# Access Compliance Report

## Public Rights-of-Way

### (Curb Ramps)

Intersection ID: 28059	Main Street: CONGRESSIONAL CLUB DR	Cross Street: THREE LAKES DR	Location: NW
ADA ID: 8CA4213D9261	Ramp Type: Perp	Initial Pass/Fail: Fail	Overall Compliance: No
			Severity Score: 12.5
Codes/Mitigation Info/Possible Solution		Field Measurements/Component Compliance

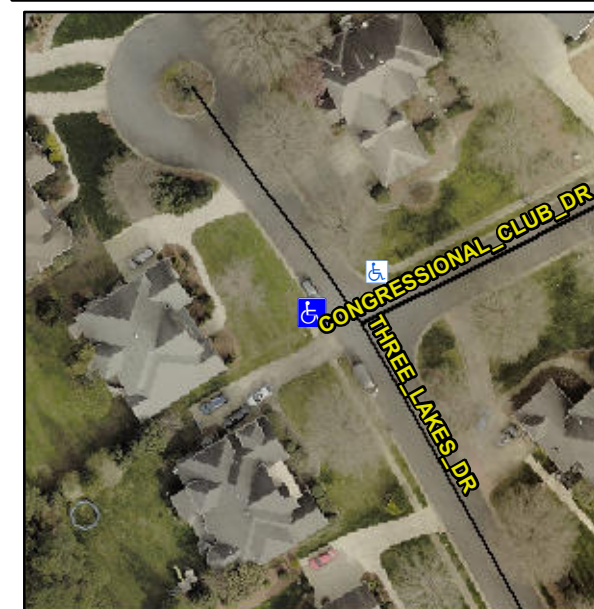
**Not Found, R304.2.2**

Compliance	Description	Data	Compliance	Description	Data
N/A	Ramp Length (in)	60.0	No	Ramp Slope (%)	8.5
Yes	Ramp Width (in)	48.0	Yes	Ramp XSlope (%)	1.0
N/A	Flare Type LT	N/A	N/A	Flare Type RT	N/A
N/A	Flare Slope LT (%)	N/A	N/A	Flare Slope RT (%)	N/A
N/A	Flare Traversable LT?	N/A	N/A	Flare Traversable RT?	N/A
N/A	Landing Length (in)	N/A	N/A	DWS Provided?	N/A
N/A	Landing Width (in)	N/A	N/A	DWS Contrast?	N/A
N/A	Landing Slope (%)	N/A	N/A	DWS Length (in)	N/A
N/A	Landing X Slope (%)	N/A	N/A	DWS Full Width?	N/A
N/A	Landing Curb? (Y/N)	N/A	N/A	DWS Offset (in)	N/A
N/A	Shared Landing?	N/A			
N/A	Gutter Ponding?	N/A	N/A	Gutter Slope (%)	N/A
N/A	Gutter Lip Ht (in)	N/A	N/A	Gutter X Slope (%)	N/A
N/A	Painted X Walk1?	No	N/A	Painted X Walk2?	N/A
	X Walk 1 Direction	To NE		X Walk 2 Direction	N/A
N/A	X Walk 1 Width (in)	N/A	N/A	X Walk 2 Width (in)	N/A
	X Walk 1 Slope (%)	3.1		X Walk 2 Slope (%)	N/A
	X Walk 1 X Slope (%)	1.1		X Walk 2 X Slope (%)	N/A

**Remove & Replace Entire Ramp.**
